# Greenwich Point Wharf Upgrade

Submissions Report

Transport for NSW | July 2022

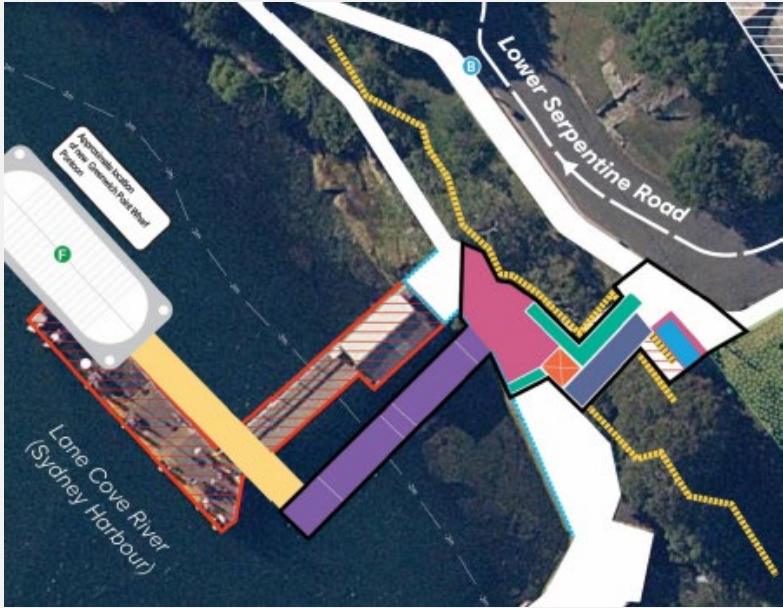
Respondents raised concerns about the length and height of the jetty and considered the design unsuitable for Greenwich Point and not integrated with the local public domain. A number of respondents suggested alternative designs including reducing the length or removing the jetty, providing a switchback ramp instead of the lift, moving the lift further east and utilising the existing heritage wharf. One respondent suggested the design process be carried out in collaboration with Lane Cove Council (LCC), and suggests the existing stairs are modified instead of replaced.

The proposed configuration of the new wharf was selected based on a number of factors including to meet accessibility gradient requirements (both on land and in most tidal states) and minimise movement of the pontoon due to the wind and wave movement, thereby maximising customer comfort and safety. The length of the jetty and gangway was determined to provide a *Disability Standards for Accessible Public Transport 2002* (DSAPT) compliant gradient of 1:14 for at least 80 percent of the tidal range.

The wharf was designed to provide appropriate clearances of existing tides, storm surge, sea and wave action whilst also considering 2070 projected sea level rise. The wharf has been designed with an operational life of 50 years. Durability and appropriate materials selection were key design criteria of the proposal. Likewise, the lift would be designed and positioned to minimise potential coastal impacts and maximise its lifespan.

Following consideration of the submissions, Transport would investigate options to reduce the length of the jetty whilst meeting accessibility, operational and safety requirements. Transport would also investigate options to reduce the height of the lift and different lift facades.
